E8801A-02

S E R V I C E N O T E

E8801A PNA Microwave Network Analyzers

Figure 1: A3 Front Panel Interface Board Assy without the Bracket

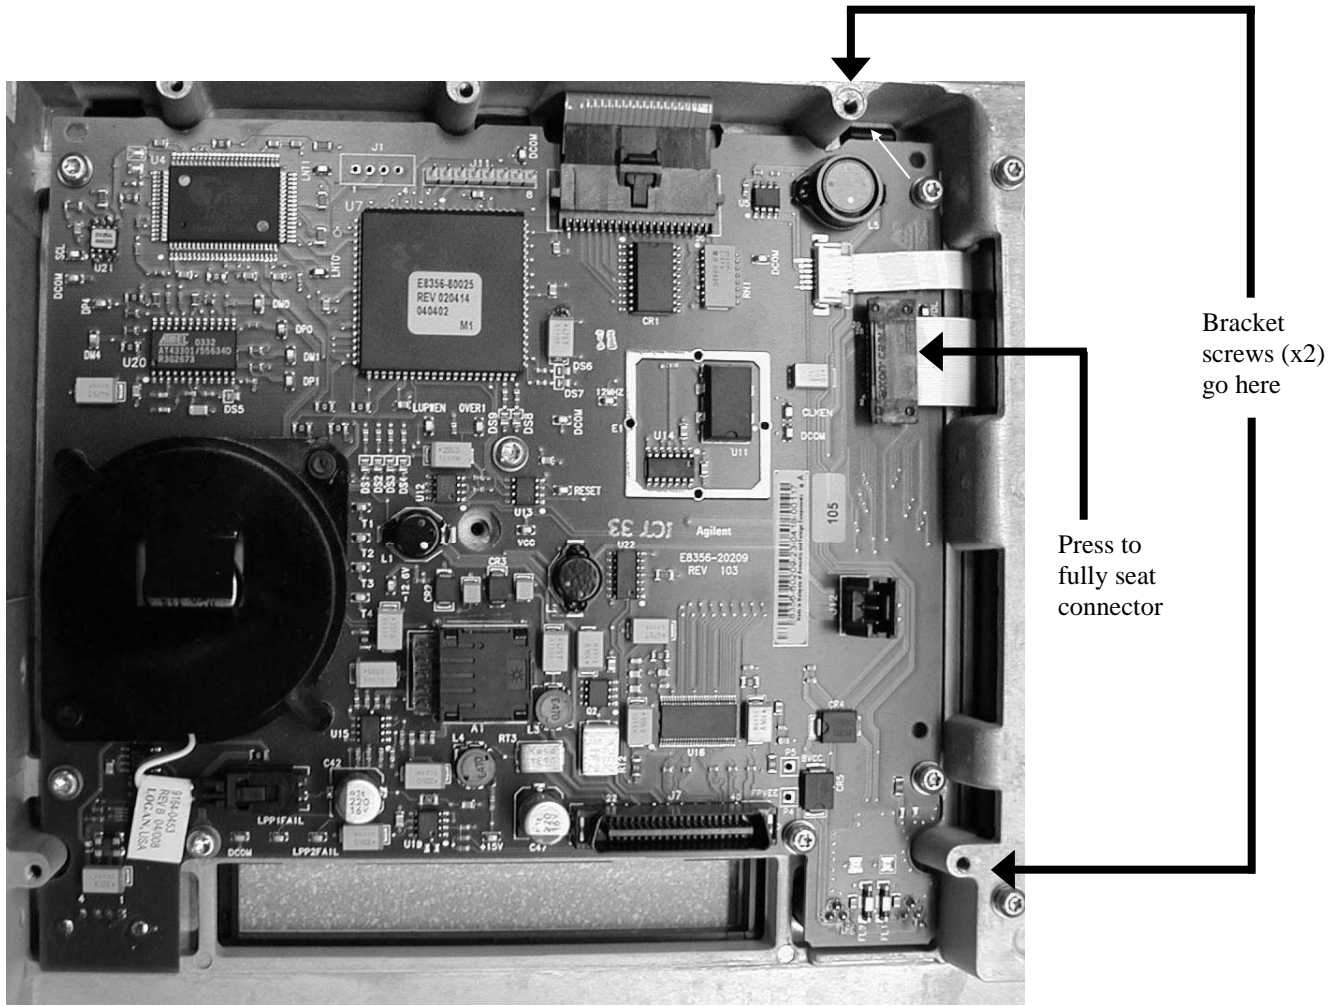
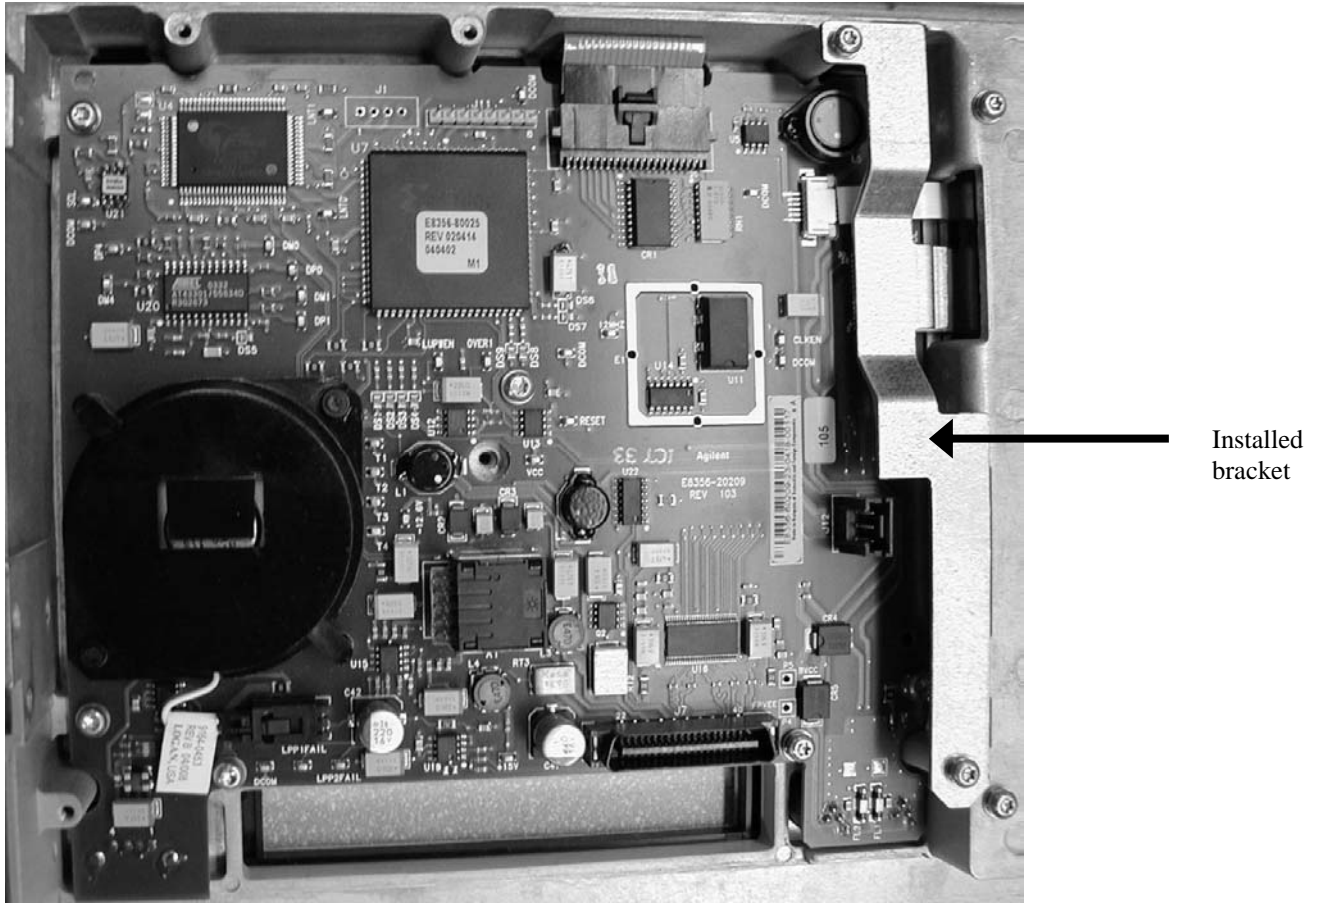
A connector of the ribbon cable (Agilent part number 8120-8409) that joins the front panel display to the front panel interface board can loosen, causing a display failure, unless a new bracket is installed. Because the failure rate has been very low, it is recommended that the bracket be installed only when there is an additional reason to remove the PNA front panel.

1. Refer to Figure 1 in this document:
 - Press down firmly on the ribbon cable's black connector.
 - Locate the two tapped holes for the bracket screws.
2. As shown in Figure 2 in this document, position the bracket so that its holes line-up with the two holes you located in the previous step.
3. Hand-start the two screws, and then torque both to 9 in-lbs.
4. Reinstall the PNA Front Panel by following the Service Guide instructions in the "Replacement Procedure." This is located on the same page as the "Removal Procedure" used previously in step 7.
